MODIFICATION REQUEST:

Amend the concept approval and Stage 1 subdivision and early works for the Eastern Creek Business Hub (SSD 5175 MOD 1)

Secretary's Environmental Assessment Report
Section 96(2) of the *Environmental Planning and Assessment Act 1979*

April 2016

Figure 8: Comparison of approved (left) and proposed (right) staging of the business hub with proposed changes circled in red

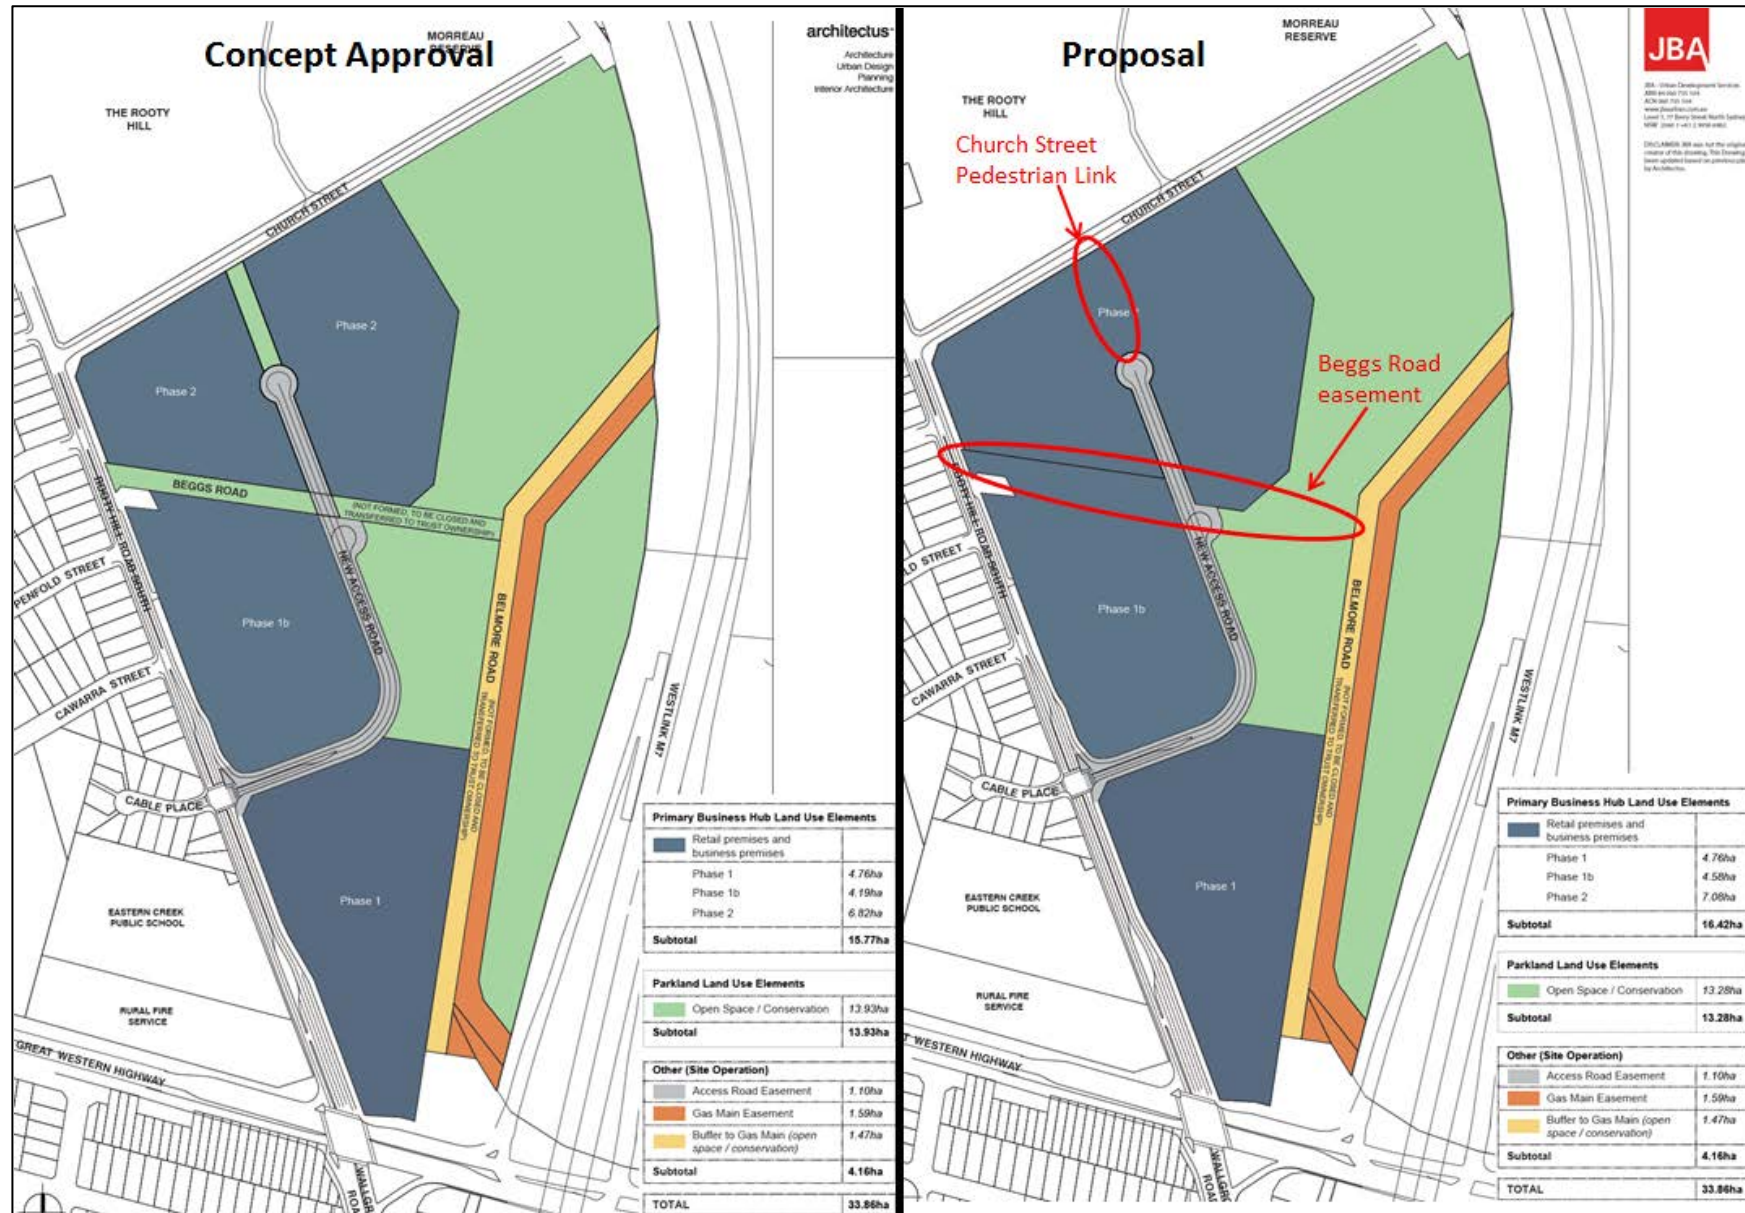
- modify the concept approval as follows:
 - transfer the Beggs Road easement into Phase 1B and Phase 2 of the business hub land;
 - maintain and incorporate the proposed pedestrian link to Church Street into Phase 2 of the development;
 - reconfigure the stormwater drainage system including provision of a second on-site detention basin; and
 - allow any residual large format retail GFA up to the approved maximum to be used as bulky goods GFA, and a maximum of 500m² of residual supermarket GFA to be used as specialty shops/small business GFA (**Table 1**).
- modify the Stage 1 subdivision and early works as follows:
 - undertake additional bulk earthworks to include remediation, establishing pad sites 1, 2, 3 and 4, and accommodate the amended stormwater drainage system.

Issue	Comment
<p>Staging</p>	<p>The proposal seeks to stage the development by:</p> <ul style="list-style-type: none"> • incorporating the Beggs Road easement into the business hub land and transferring it into Phase 1B and Phase 2 of the development; and • maintaining and incorporating the proposed pedestrian link to Church Street into Phase 2 of the development (Figure 8). <p>The applicant contends the incorporation of both the Beggs Road easement and pedestrian link to Church Street is sought to remove the requirement for further administrative modifications to the concept approval once the Beggs Road easement has been transferred from Blacktown Council to the Western Sydney Parklands Trust.</p> <p>The Department notes that the Beggs Road easement is an unformed road running through the northern part of the site and the pedestrian link connects Church Street to the new access road. Both are currently under the ownership of Blacktown Council. The original concept approval identified that these easements would not be developed and will be transferred to the ownership of Western Sydney Parklands Trust.</p> <p>The proposed staging will not impact on the overall delivery or intent of the concept approval for the easements and is considered acceptable.</p>

Figure 9: Extract of proposed bulk earthworks plan showing pad sites and levels

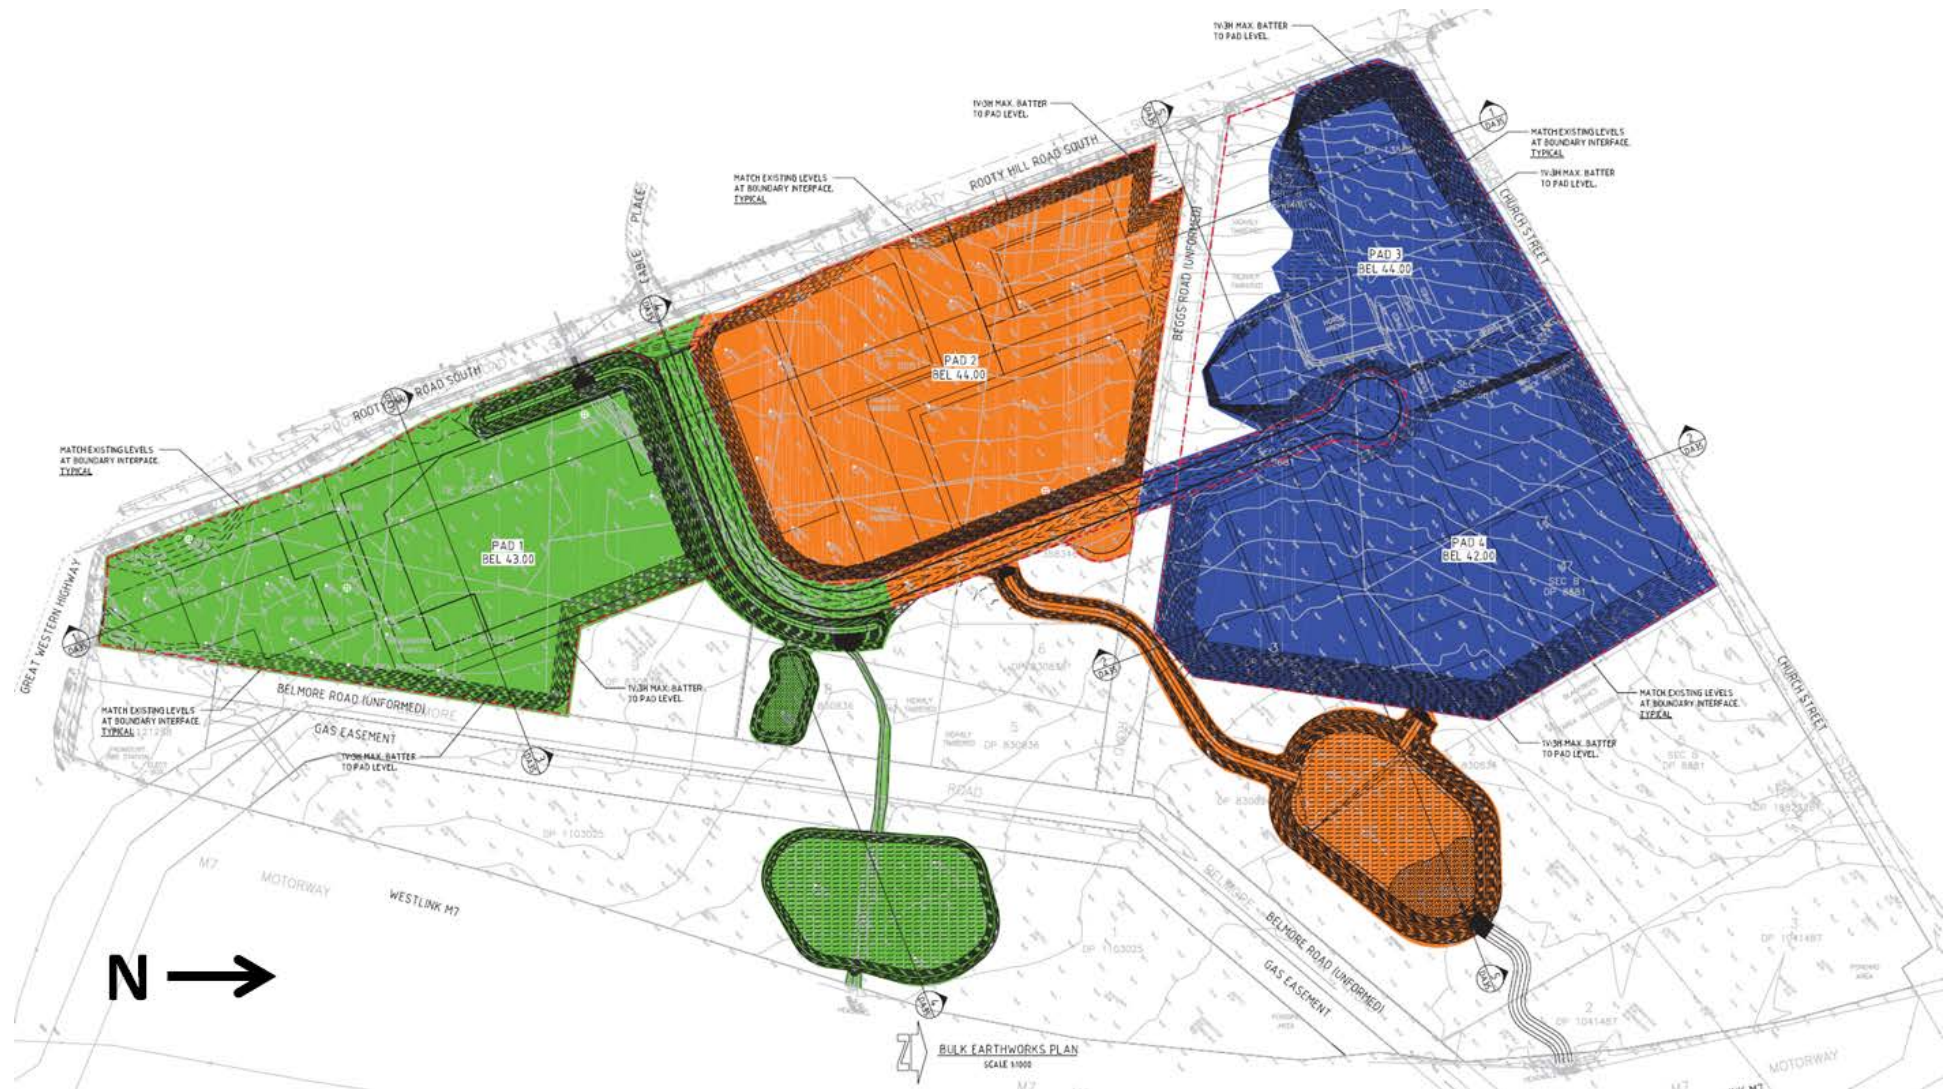
The proposed changes to bulk earthworks are considered necessary as part of the detailed design for the construction of the site and minor in nature. The bulk earthworks maintain the approved layout and seek to establish building platform levels as summarised in **Table 4** below:

Council requested that an updated visual impact assessment be submitted to aid the assessment of the potential changes in building height from the proposed pad site levels. Council also commented that pad site 2 retaining wall alignment at the north western corner should be adjusted to provide a better transition to adjacent remnant bushland and adjacent remaining cottage.

The Department notes the proposed level for pad site 2 of RL 44m has resulted in the removal of the retaining wall at the north west corner and will provide a pad level generally consistent with the existing ground levels of the adjoining remnant bushland and adjacent cottage. Further, the applicant's heritage consultant contends that adjustment of building pad levels would not change the visual impacts to any historical or aboriginal archaeology. The Department agrees and is satisfied that the realigned levels provides an appropriate transition to remnant bush.

Figure 10: Extract of maximum building foot prints showing minimum setbacks to Rooty Hill Road South

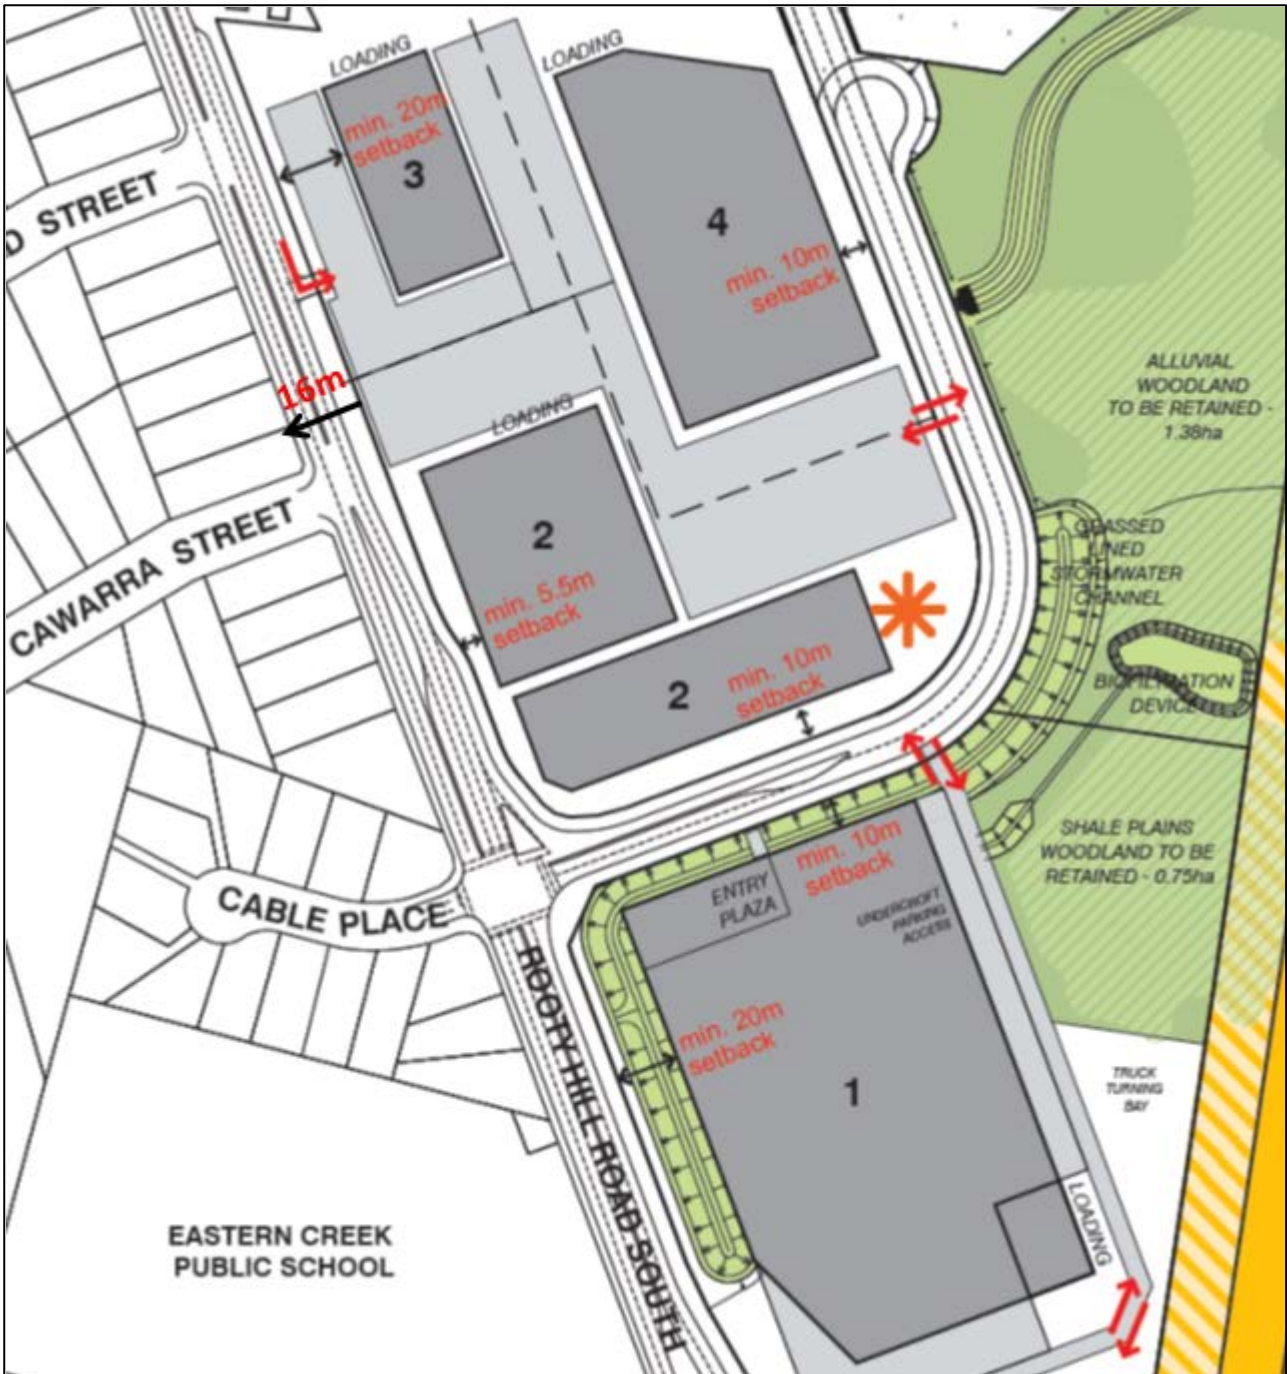
Further, the Department notes future buildings on the site will be setback between 21.5 and 116 metres from the nearest residential boundary (**Figure 10**). Given the significant setbacks and general consistency with existing levels, the Department considers that any minor variations in building height would not be visibly discernible from the streetscape. In addition, any increase would not alter the scale/form of future buildings.
